*Southern California Edison Company*

Subject: Docket Nos. 50-361 and 50-362  
San Onofre Nuclear Generating Station  
Units 2 and 3

RESPONSES TO NRC QUESTIONS  
SAN ONOFRE NUCLEAR GENERATING STATION  
UNITS 2 & 3

SEPTEMBER 3, 1980

Figure 121.21-9

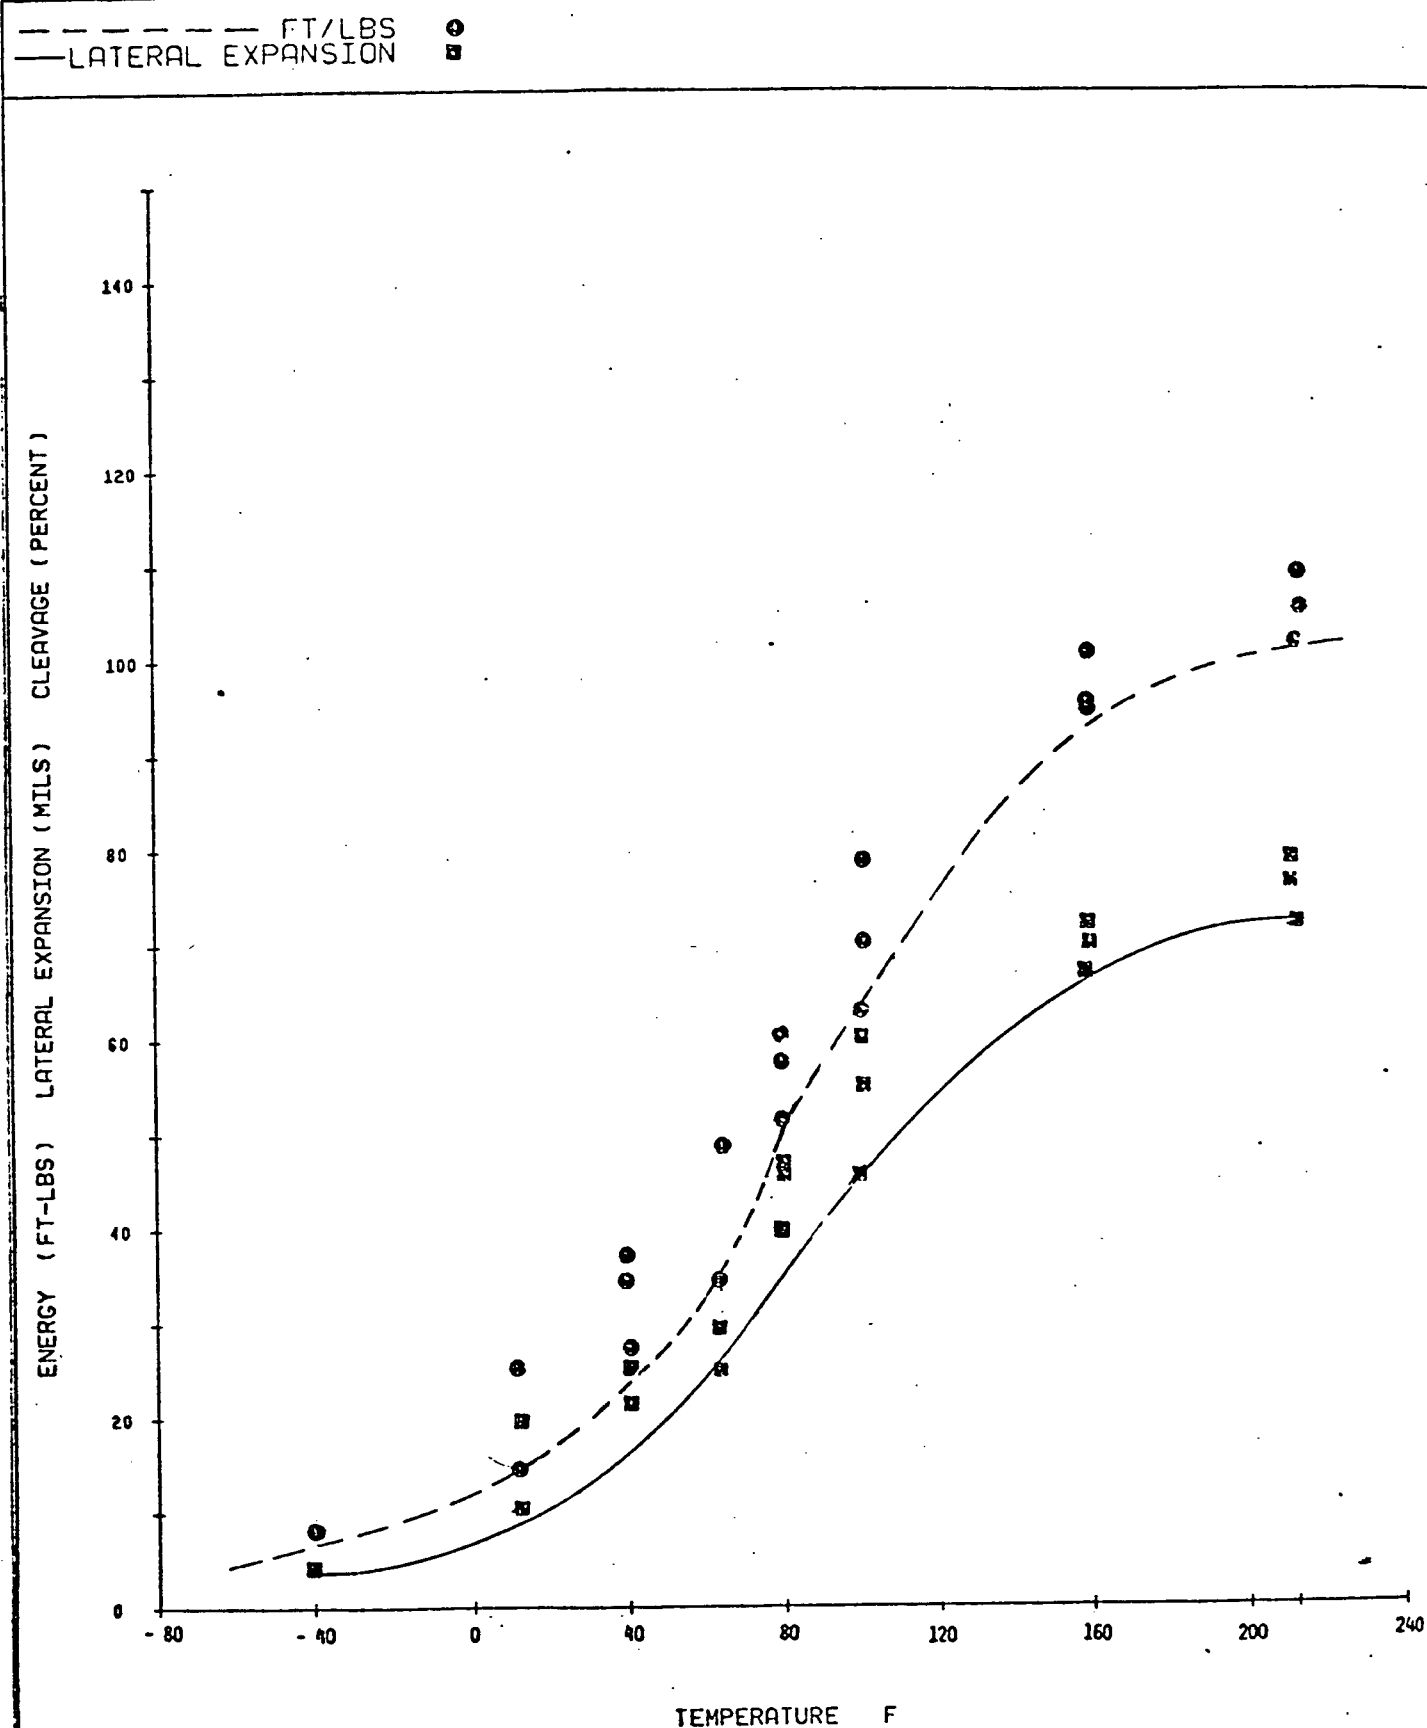
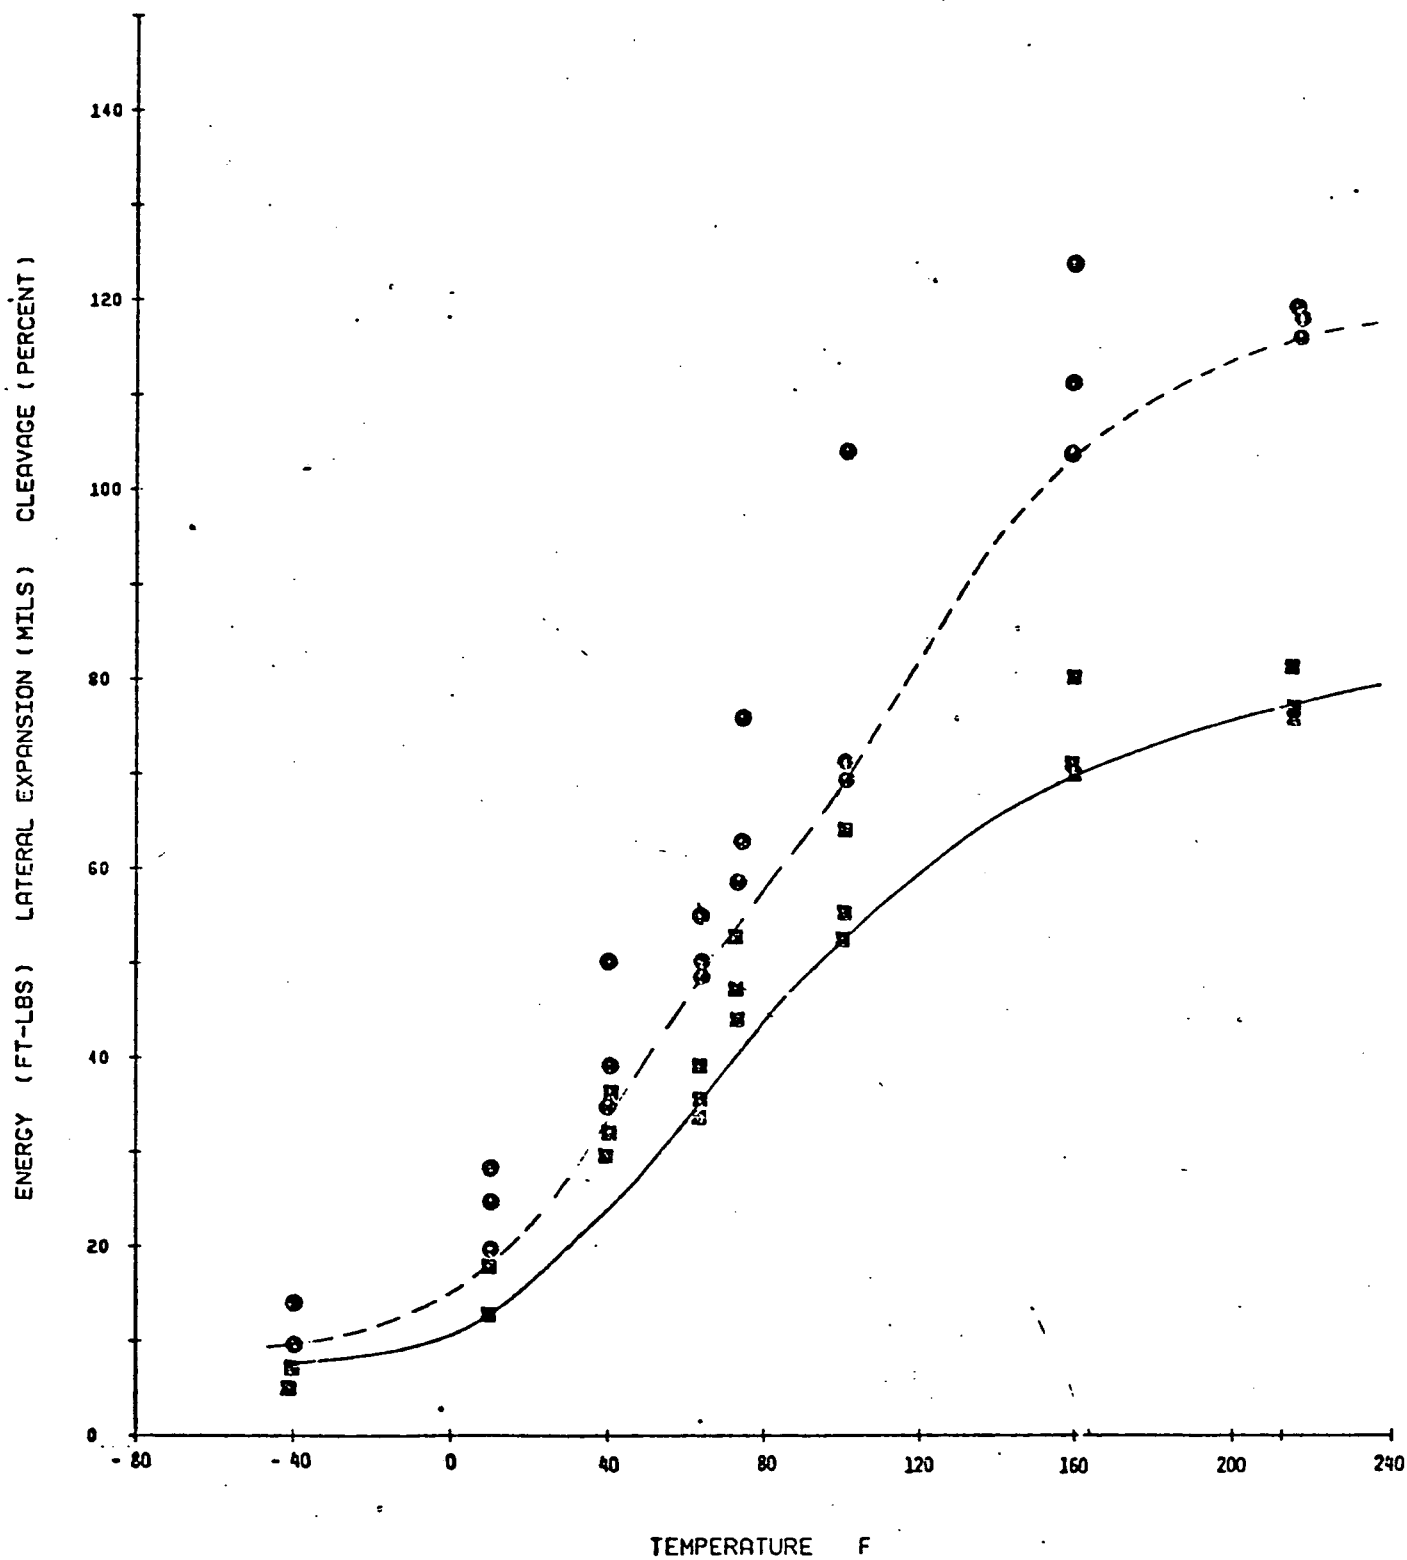
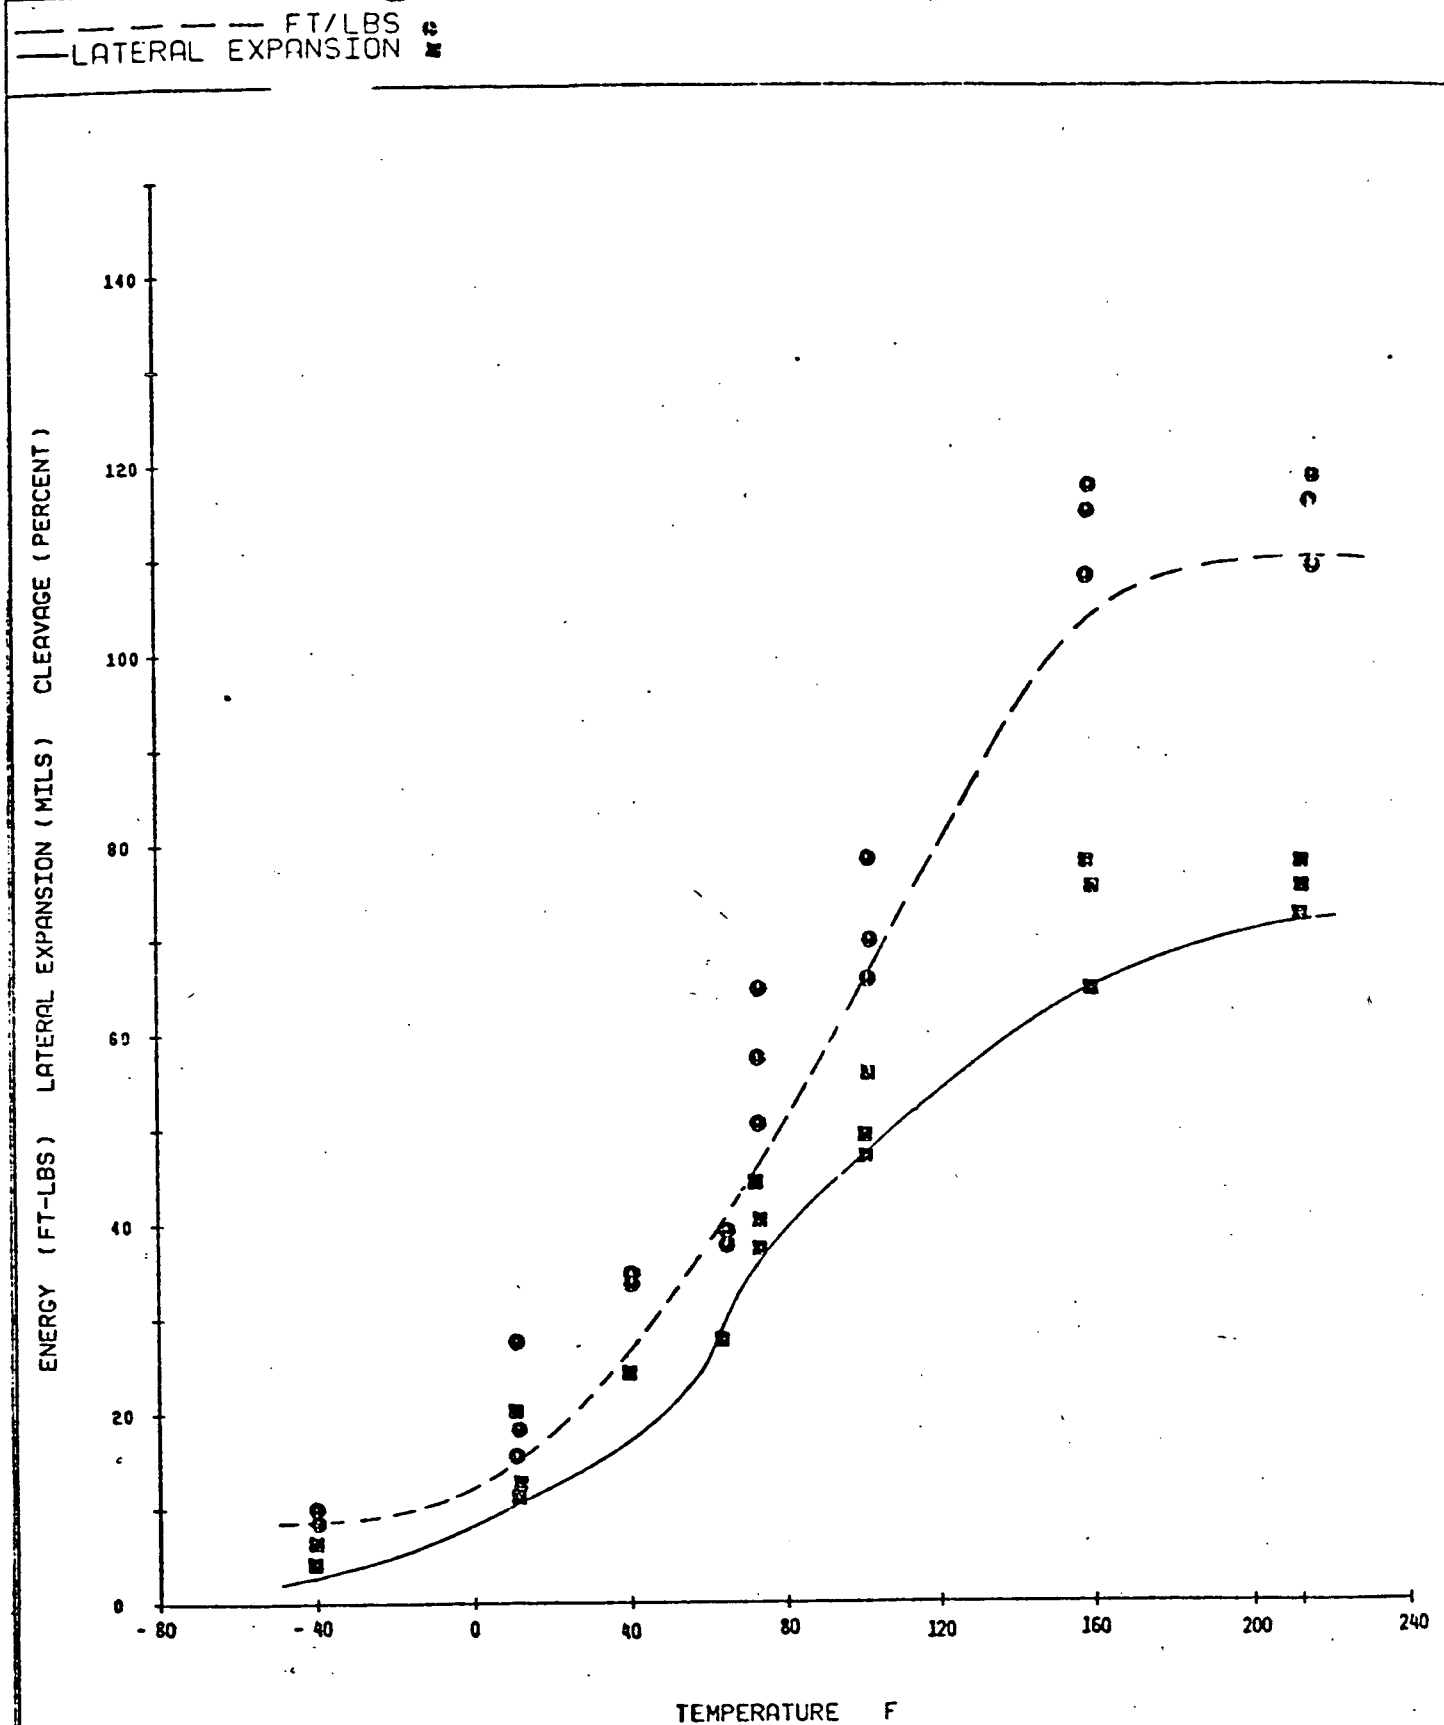
- (1) for the reactor vessel beltline materials, provide full Charpy V-notch curves, including data points, reported in impact energy and lateral expansion, both as a function of temperature;

- (1) Beltline materials Charpy test results for Units 2 and 3 are shown in Figures 121.21-1 through 121.21-12, respectively. The data points have been included. Tables 121.12-1 through 121.21-12 provide the data in tabular form corresponding to the Figures. The revised FSAR figures will be provided by 9/15/80 showing the Charpy test results.
